Solar PV String Inverter System Inspection Report

Project Name:	D. Jacobson & Sons Ltd	Contractors Name and Address
Installation Address:	Bacup Road, Rawtenstall, BB4 7PA	MBC Renewables Ltd 14 Fairview Drive Medomsley Edge Consett Co. Durham DH8 6QX
Tested by:	Michael Middlemast	Signature:
Project Reference:	JACOBSON001	
Commissioning Date:	2022	
Test Start Time:	29/05/2023 10:10 AM	
Test End Time:	30/05/2023 10:45 AM	
Rate kWp of plant:	100kWp

SAMPLE
SITE IMAGES

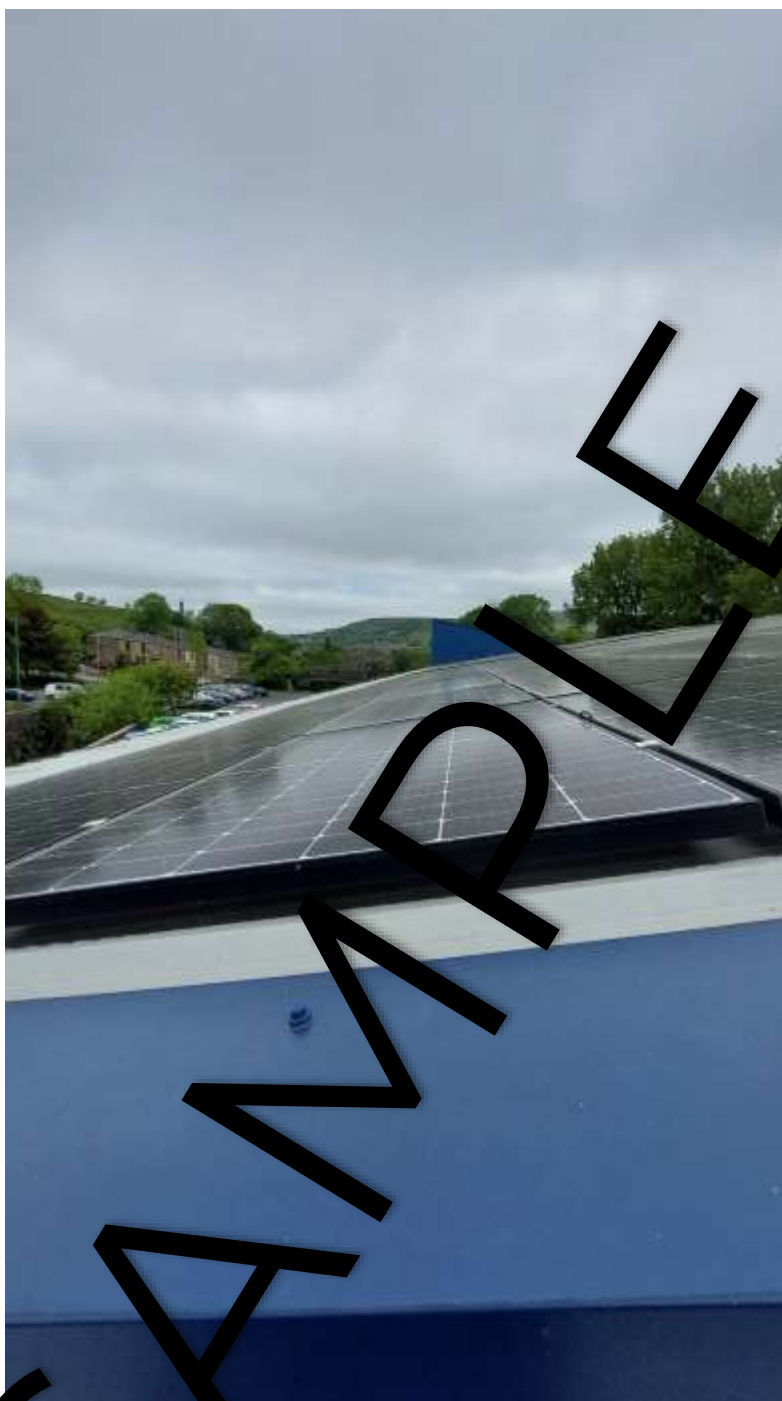
Loose cables can be seen from the top side of the array.

These loose cables are then subject to the elements and movement over time. This loosens connections causing the insulation faults on the array.

The full width of cable trays has not been utilised and TAPE has been used to hold cables together (*see images*) this is not in line with code.

Inverters are exposed to the elements and harsh environment. This is not in line with the manufacturer's suggested installation instructions and **will void any warranty**. Suggest installation of housing and protective cover.

System is not properly grounded (*see images*)

Around the installation is litter from the installation crew and old installation manuals (*see images*). This poses further fire risk and suggests "bad practice" culture amongst installers.

- Prepare correct PPE for works
- Perform pre-IEC62446 tests Category 1 and 2, record results
 - o Module level testing
 - o String level testing
- Modules cleaned, obstructions removed and inspect roof
- Install equipotential earth bonding
- Calculate and install correct size of cable for DC cable runs, 6mm not 4mm?
- Replace damaged inverters – check new inverter warranty status
- Correctly string the modules to inverters in line with code
- Re-run AC cabling to internal DB (*Approx 60/80M length*)
- Upgrade all switch gear
- Add Schematic, shut down procedure etc.
- Add inverter housing
- Perform post-IEC62446 test Category 1 and 2, record results
- Clear area of obstructions and litter
- Add Greenworld communications system for safety and monitoring
- Add avian deterrents, netting
- Perform annual visual inspection and IEC62446 testing
- Perform annual cleaning routine
